# Agenda Item #2

## Application 2024-14-CA

407 Church Street

Replace five pairs of shutters on west elevation with PVC composite shutters.

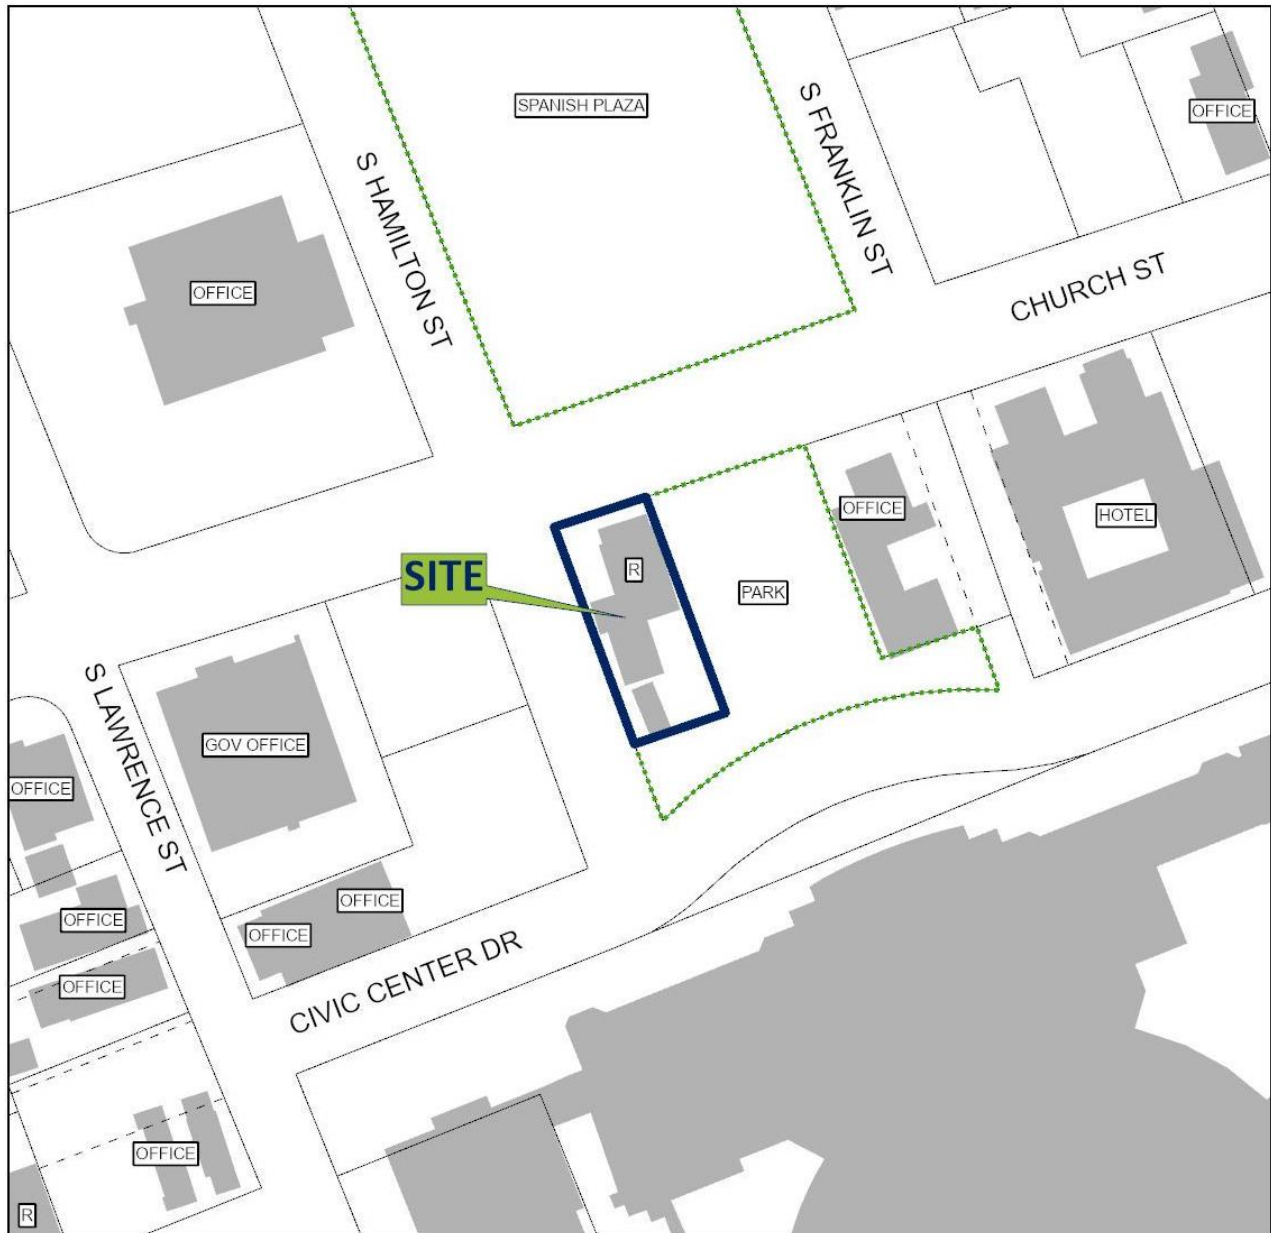
The property under review is a contributing structure in the Church Street East Historic District. The application proposes the installation of five (5) pairs of new shutters on the west elevation of the house. The shutters would replace existing wood shutters which are deteriorated. According to the applicant, efforts to maintain and repair all shutters at the property have been ongoing. However, the shutters on the west elevation in particular are now in such an advanced state of deterioration, repair work is no longer a feasible option.

The proposed new shutters would be installed on the west elevation of the main block of the house and would flank two historic windows on the second floor and three windows on the first floor (as noted in the accompanying photo). The proposed shutters are of a PVC composite material that closely simulates the appearance of wood, which is directed by the *Guidelines* when using an alternative material. The shutters would be customized to closely match the dimensions and profile of the existing shutters. They would be fixed shutters that appear to be operable. (5.25)
